**Subject: Beaver Valley Power Station, Unit Nos. 1 and 2  
BV-1 Docket No. 50-334, License No. DPR-66  
BV-2 Docket No. 50-412, License No. NPF-73  
Supplement to License Amendment Request Nos. 296 and 169,  
Improved Standard Technical Specification Conversion**

**BEAVER VALLEY POWER  
STATION  
UNITS 1 & 2**

**IMPROVED TECHNICAL SPECIFICATION  
CONVERSION  
LICENSE AMENDMENT REQUEST**

**REVISION 3**

INSERT 1

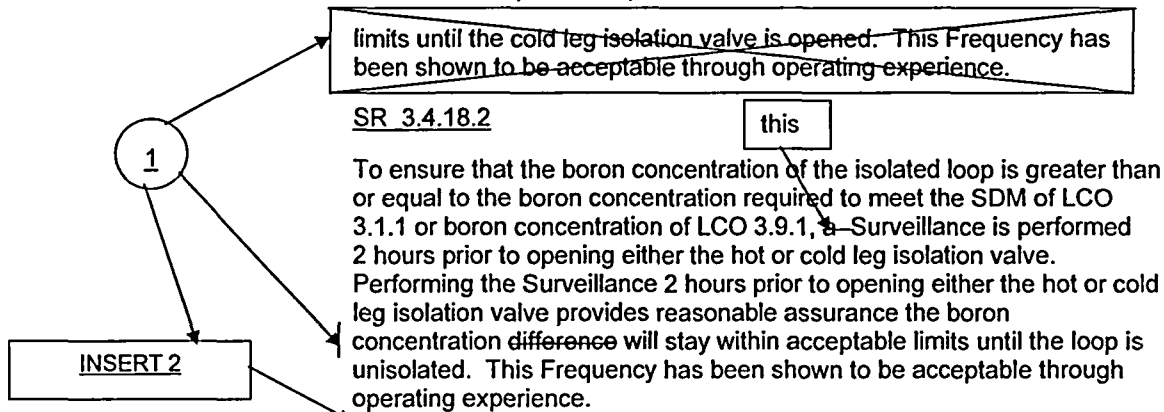
1. The ISTS Bases is revised to reflect changes made to the corresponding LCO 3.4.18 to maintain the BVPS CTS requirements for isolated loop startup. BVPS is maintaining the current NRC approved technical specification requirements for isolated startup. Changes to the ISTS 3.4.18 Bases are made as necessary to conform to the BVPS CTS licensing basis for isolated loop startup.

2. The ISTS bases text is revised to eliminate the RCS loop isolation valve interlock discussions from the Background and Safety Analysis description. Although BVPS has valve interlocks which prevent opening of the RCS hot and cold leg isolation valves and the start of a RCP, these interlocks are not relied on in the technical specifications for the startup of an isolated loop. The CTS bases only credits administrative controls to ensure the controlled startup of an isolated loop. In addition, as described in the BVPS UFSAR Section 14.1.6 (Unit 1 and UFSAR Section 15.4.4 (Unit 2) the interlock for opening a cold leg loop stop valve may be procedurally bypassed. The current (CTS) and proposed (ITS) controls required by the TS for isolated loop startup provide sufficient assurance that the startup of an isolated loop will be accomplished in a controlled manner without introducing unacceptable changes in boron concentration or temperature in the RCS. The operability or availability of these interlocks is not part of the CTS or proposed ITS.

3. The bases description regarding how the RCS isolation valves may be used in Modes 5 and 6 is revised to be less specific. The bases should not limit the use of isolation valves in these Modes to maintenance activity only.

4. The ISTS Applicability discussion is revised to reflect the fact that all RCS loops may be isolated in Modes 5 and 6. RHR may continue to be used for decay heat removal with all RCS loops isolated and the availability of the RCS loops does not affect the required SDM. Therefore, the ISTS reference to the "SDM of the operating loops" is revised to delete "of the operating loops".

TSTF-449, Rev.4

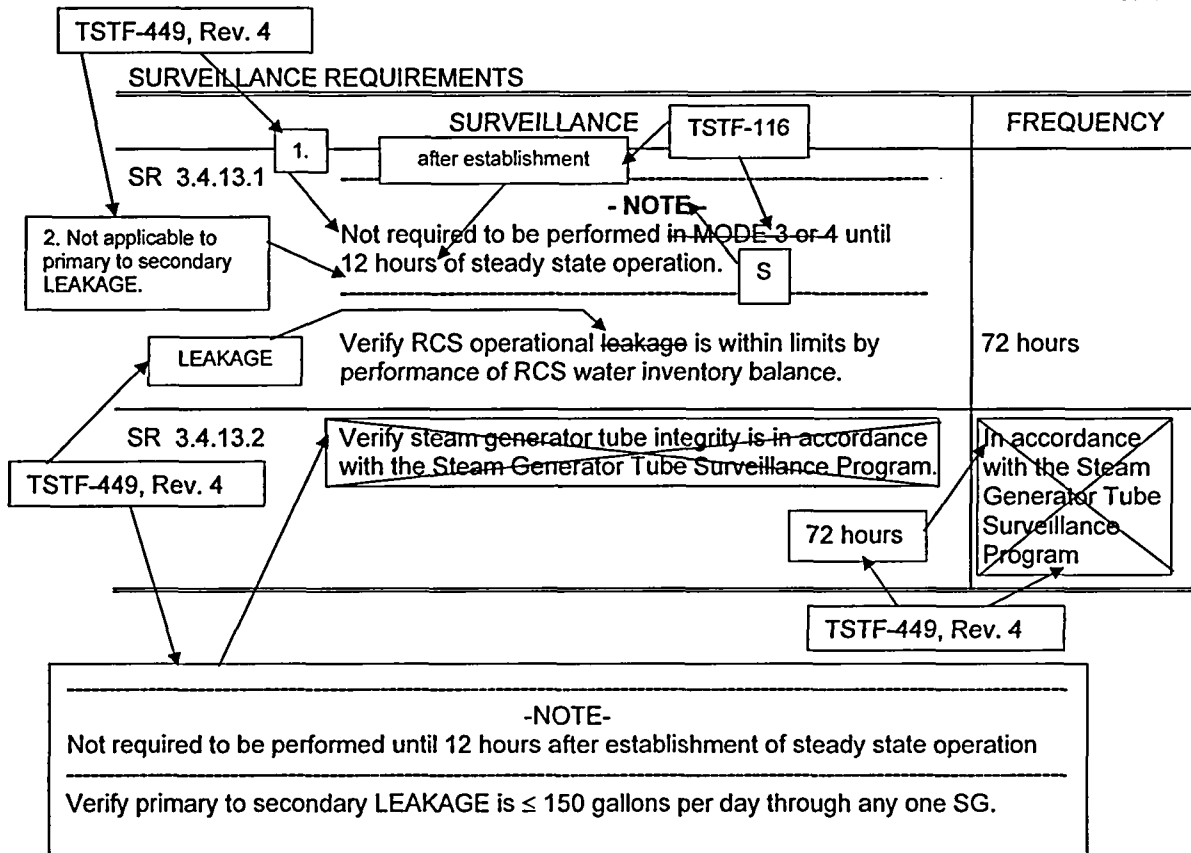
1. The ISTS 3.4.13 steam generator leakage requirements are revised consistent with the BVPS CTS requirements. The Unit 2 BVPS specific requirements for steam generator leakage are consistent with the guidance of NRC Generic Letter 95-05, "Voltage-Based Repair Criteria for Westinghouse Steam Generator Tubes Affected by Outside Diameter Stress Corrosion Cracking." The NRC has specifically approved the Unit 2 BVPS CTS leakage limits in Amendment 101 issued 8/18/99. The BVPS Unit 1 Leakage Limits were recently reviewed by the NRC in association with the approval of the Unit 1 Replacement Steam Generator Amendment 273 issued 2/9/06. In addition, these changes are consistent with TSTF-449, Rev. 4.

B.1 and B.2

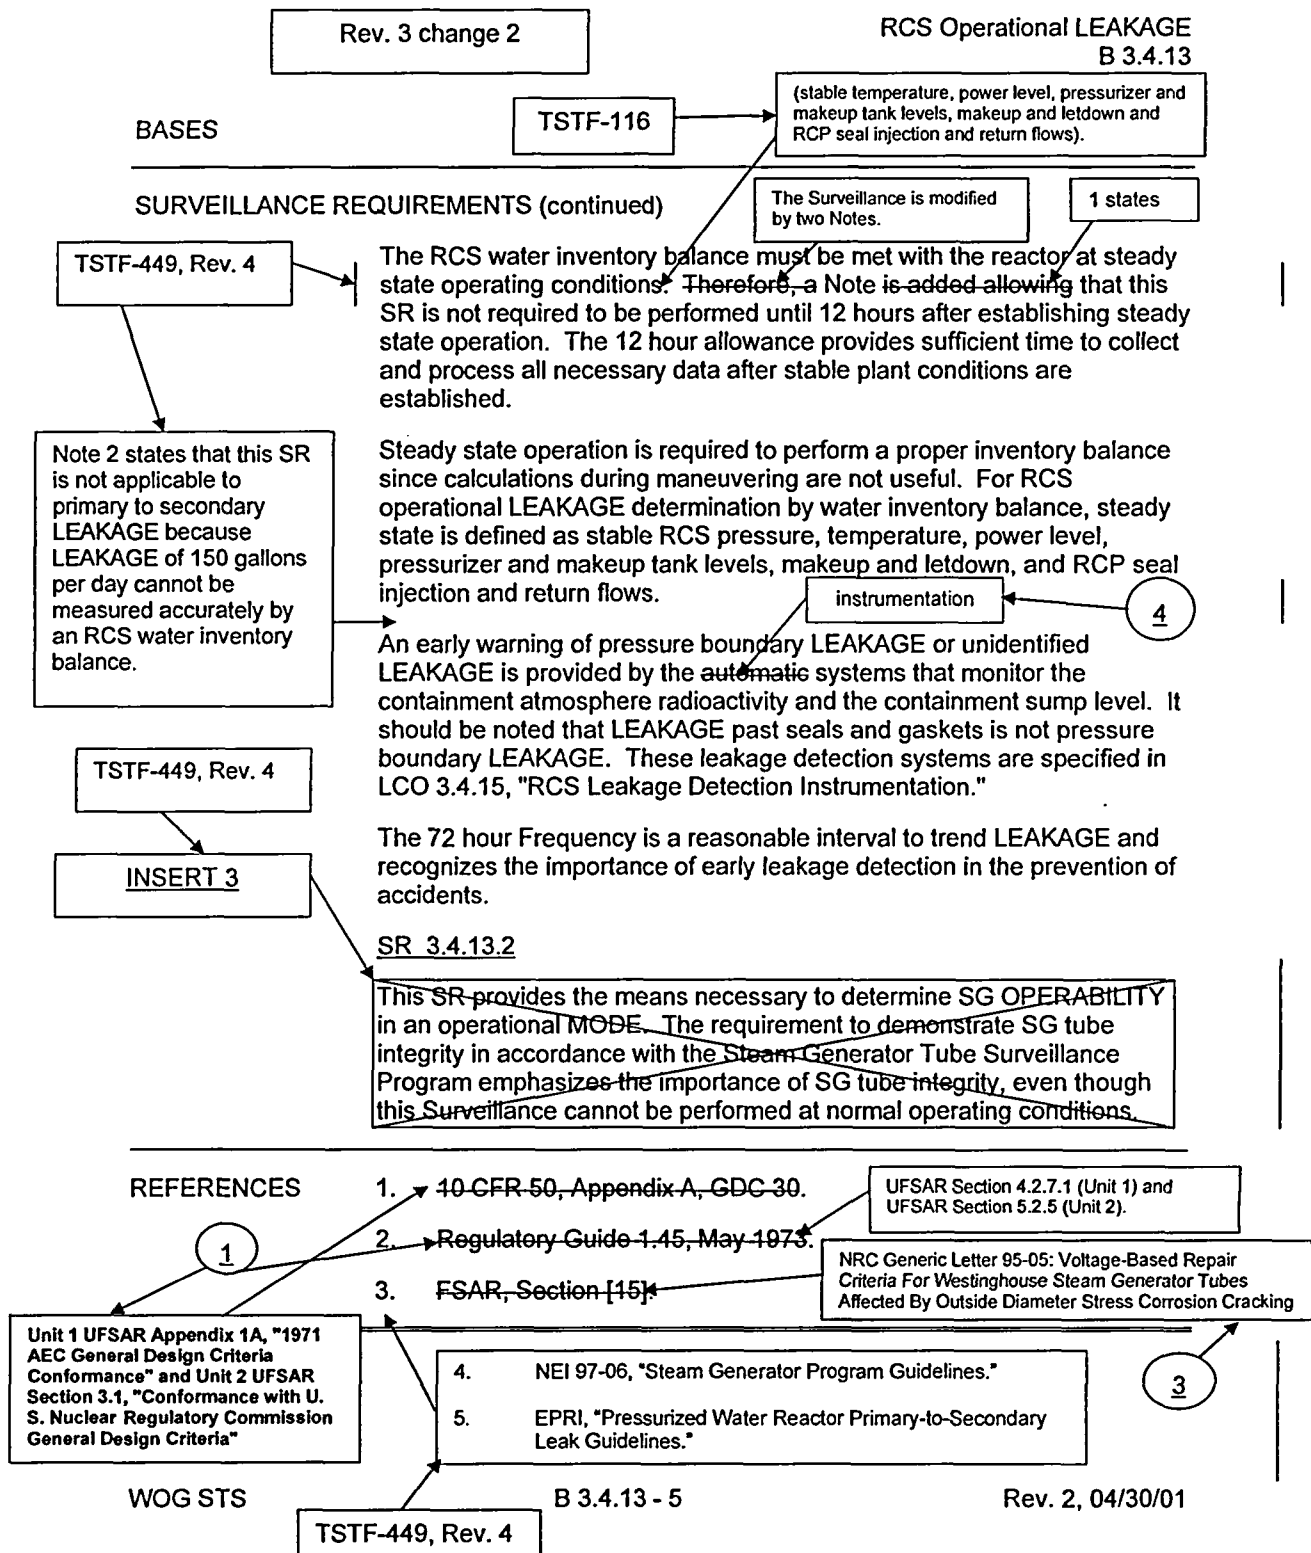
or primary to secondary LEAKAGE is not within limit,

If any pressure boundary LEAKAGE exists, or if unidentified LEAKAGE, identified LEAKAGE, or primary to secondary LEAKAGE cannot be reduced to within limits within 4 hours, the reactor must be brought to lower pressure conditions to reduce the severity of the LEAKAGE and its potential consequences. It should be noted that LEAKAGE past seals and gaskets is not pressure boundary LEAKAGE. The reactor must be brought to MODE 3 within 6 hours and MODE 5 within 36 hours. This action reduces the LEAKAGE and also reduces the factors that tend to degrade the pressure boundary.

**3.1.6, Control Bank Insertion Limits, SR 3.1.6.1 (Bases change only)**

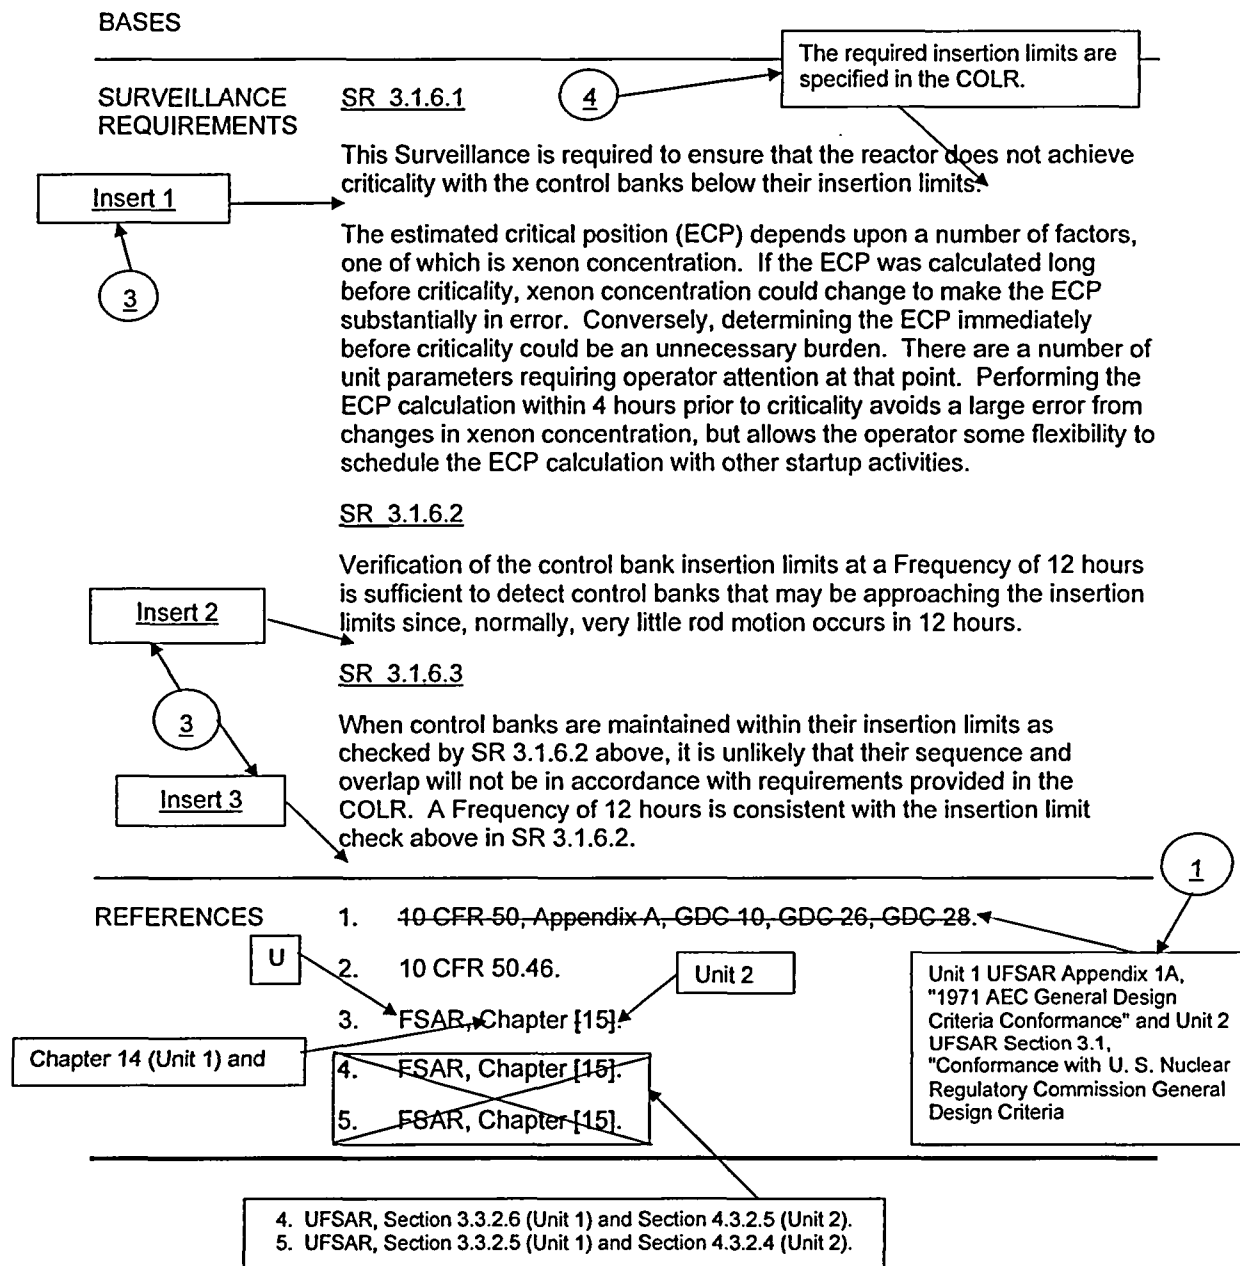
ITS SR 3.1.6.1 refers to the limits specified in the Core Operating Limits Report (COLR). The Bases description of the SR is revised to clarify that the specific COLR limits referred to in the SR 3.1.6.1 are the control bank insertion limits.

2. The bases discussion regarding control rod overlap and example figure B 3.1.6-1 is revised to more clearly describe overlap and the tip-to-tip relationship between control banks shown in the BVPS specific example figure. The proposed change is not intended to introduce a technical change to the bases.

**Description**

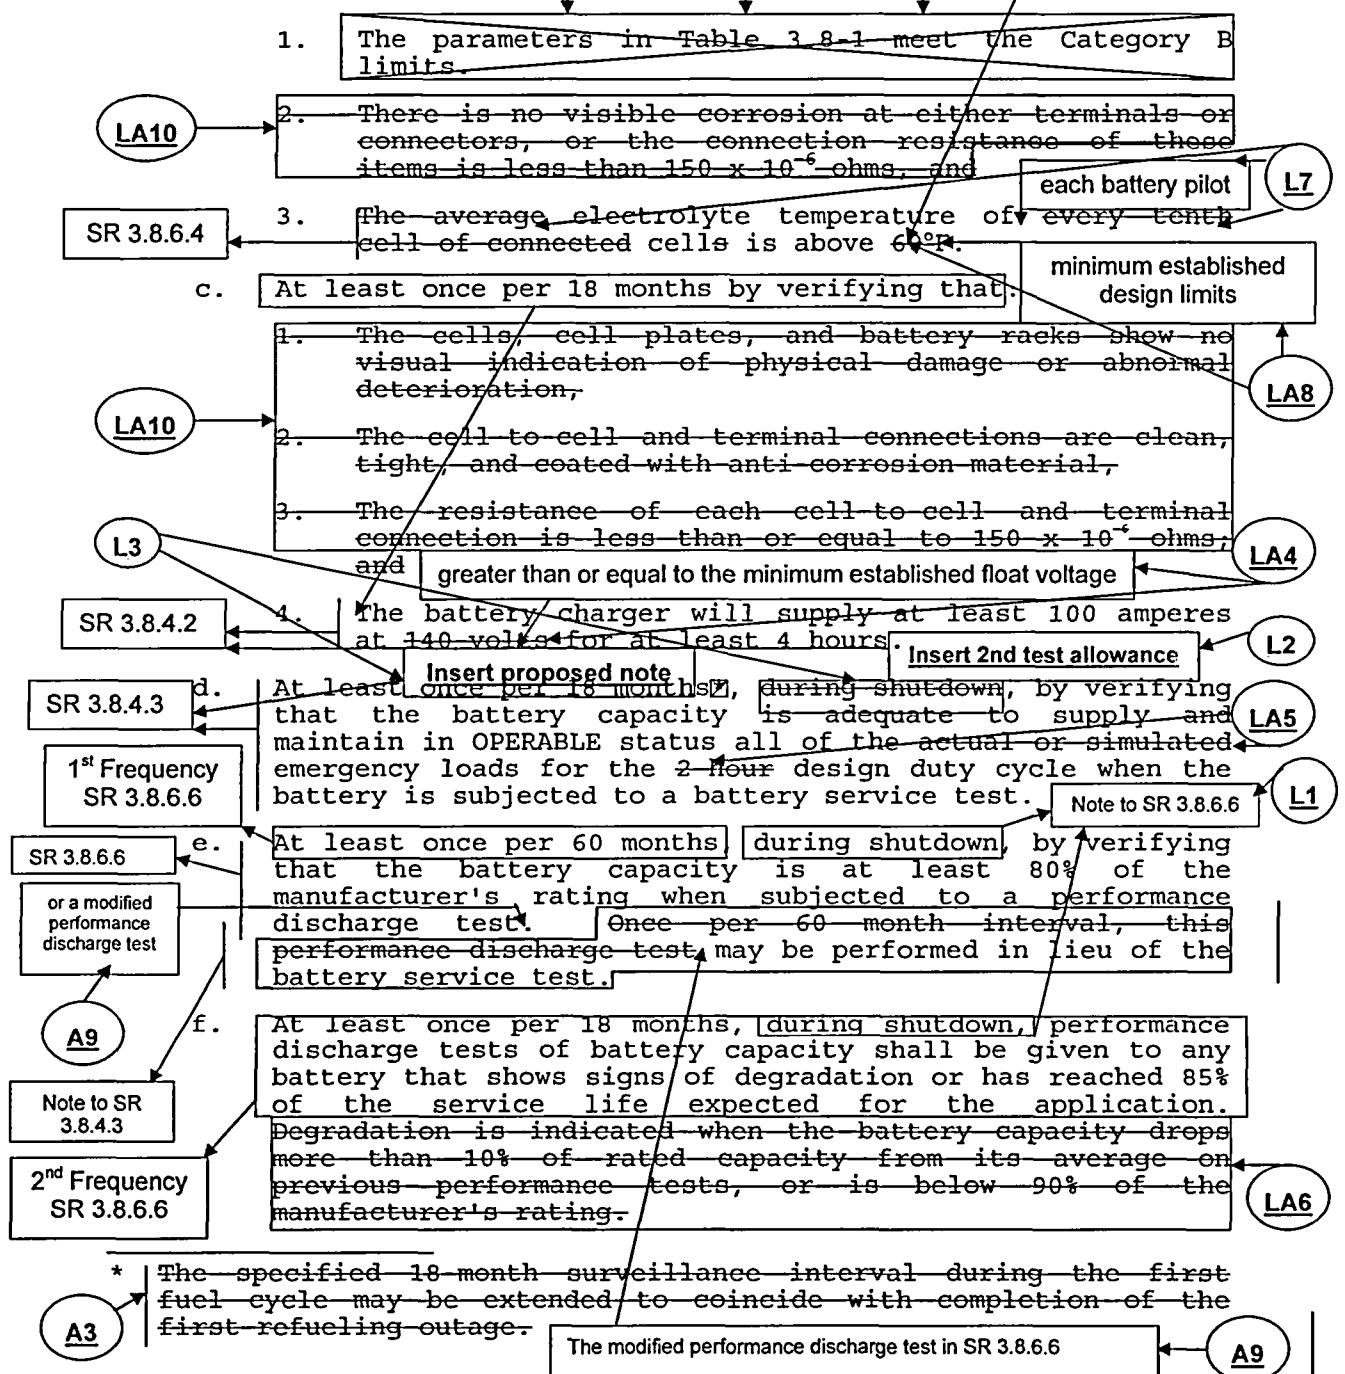
ITS Surveillances Requirements 3.8.4.3 and 3.8.6.6 allow for the option to use a modified performance discharge test. The corresponding markup of CTS Surveillance 4.8.2.3.2.e on CTS page 3/4 8-10 is revised to more clearly show the option to use a modified performance discharge test. The improved CTS markup resulted in the addition of a new DOC (A.9) on the same page. This change also includes the deletion of an unnecessary arrow line from the LA6 DOC designation to an unrelated change on the same CTS page. These changes do not affect the resulting ITS and are only intended to improve the clarity of the CTS markups.

**3.8.1, AC Sources – Operating, SR 3.8.1.13 ITS and Bases change**

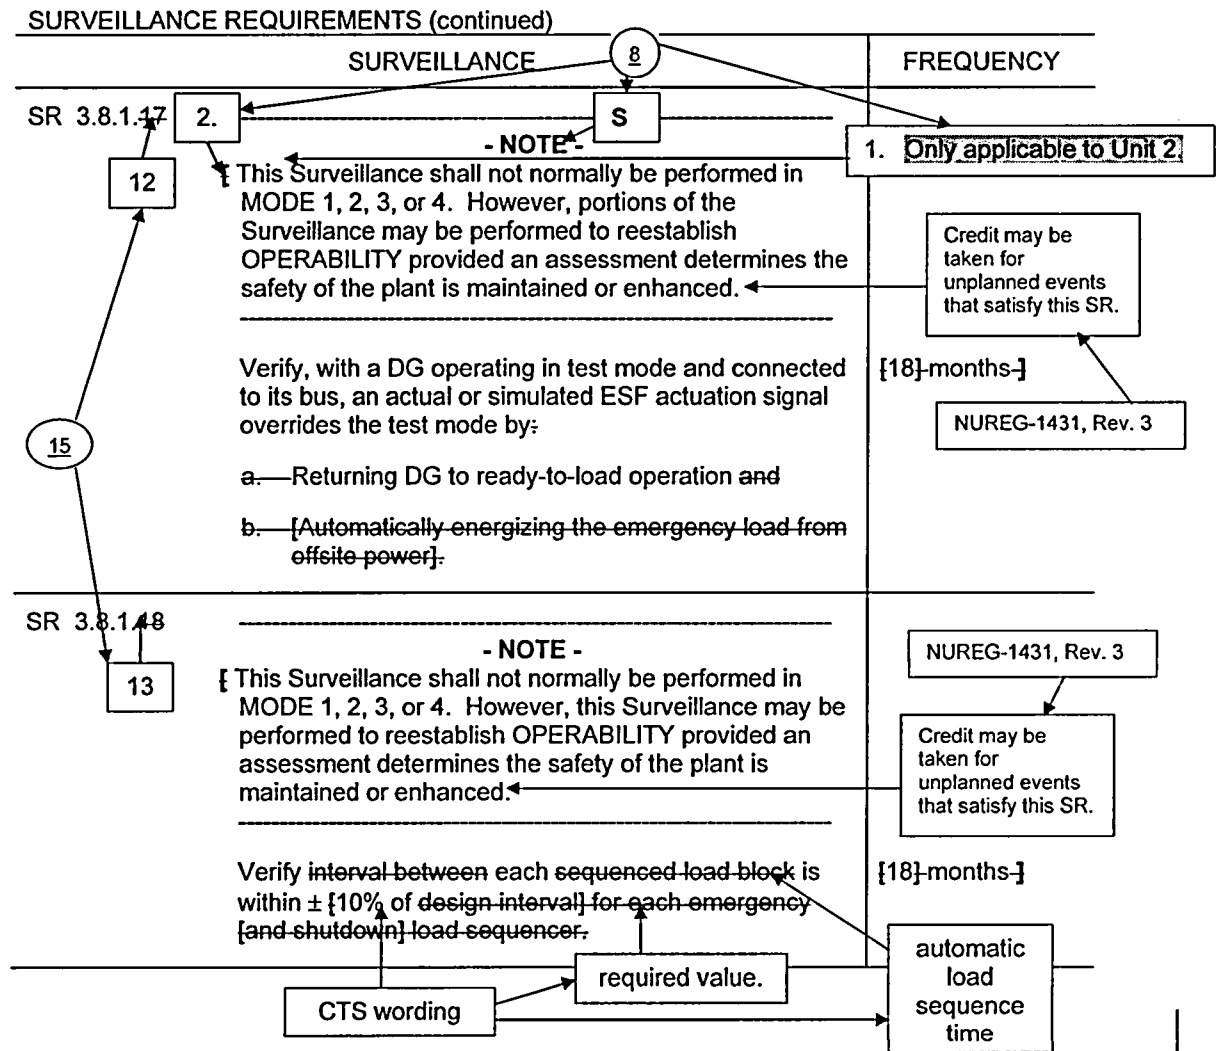
This change revises ITS SR 3.8.1.13 and associated Bases to be more consistent with the corresponding plant specific CTS requirements. In ITS SR 3.8.1.13, the phrase "...each automatic load sequence timer is within  $\pm 10\%$  of required value." is revised to "... each automatic load sequence time is within  $\pm 10\%$  of required value". The associated Bases is also revised to more accurately state the surveillance requirement. These changes are made to maintain consistency with the CTS and avoid potential confusion regarding the use of the word "timer" and "interval" in the ITS and Bases.

## 5.5 Programs and Manuals

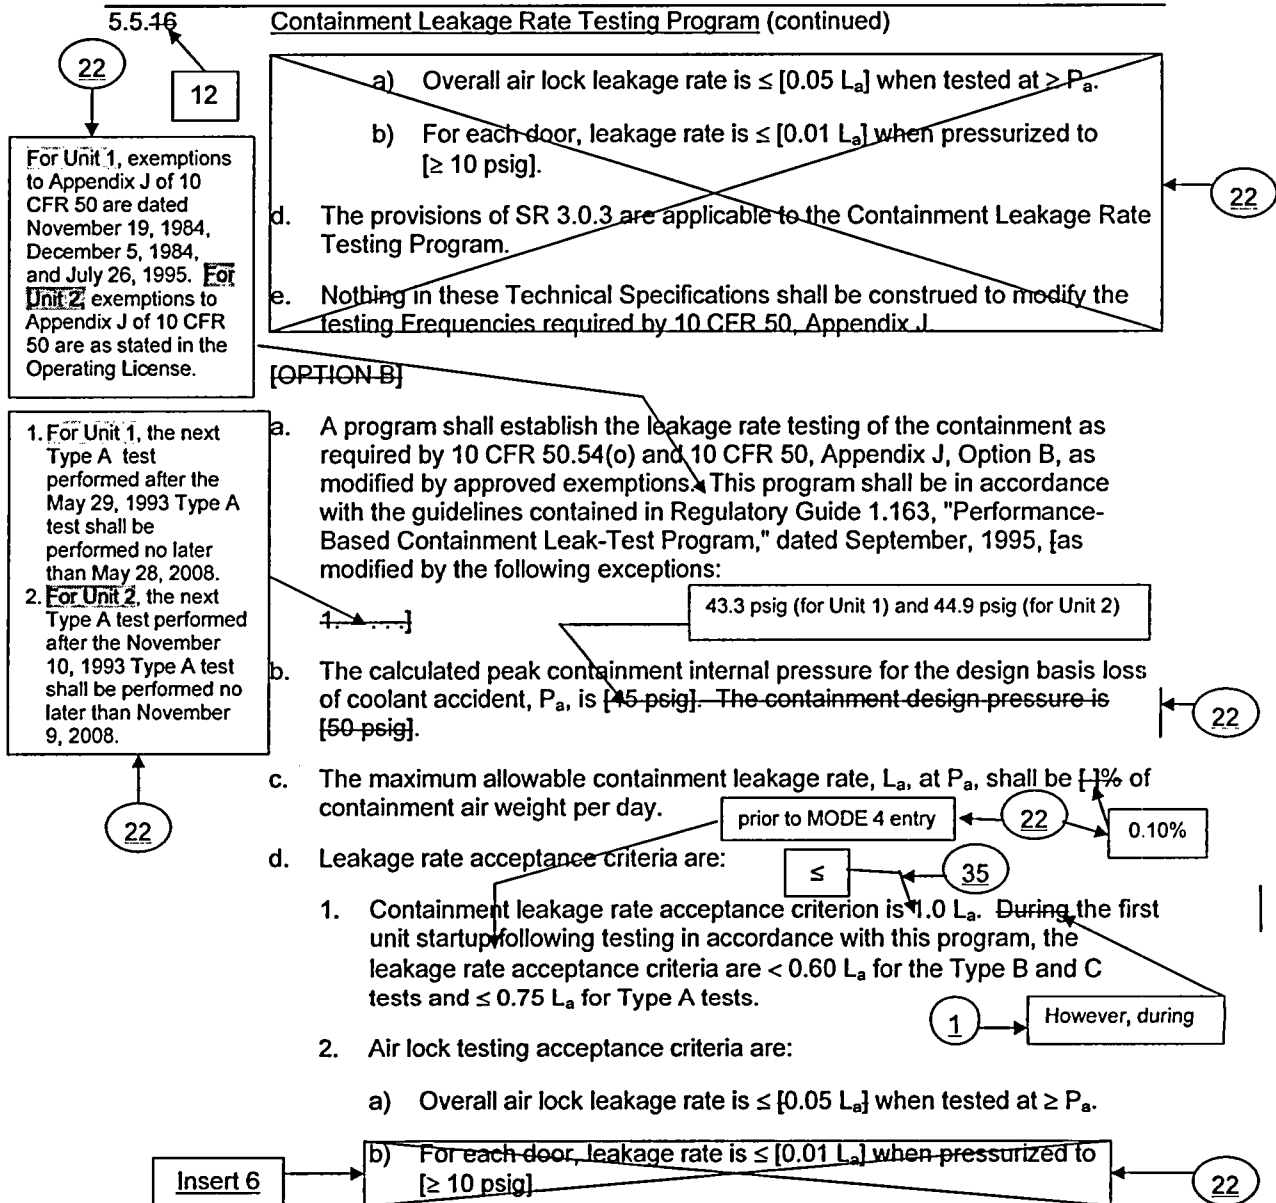
The proposed change is based on approved TSTF-479 as modified by agreement with the NRC. The agreed change deviates from the approved TSTF-479 in that it restricts the test interval extension provided by SR 3.0.2 to inservice test intervals of 2 years or less. The change to TSTF-479 is based on the fact that the inservice test intervals > 2 years provide adequate time to schedule the required testing without the additional extension provided by SR 3.0.2.
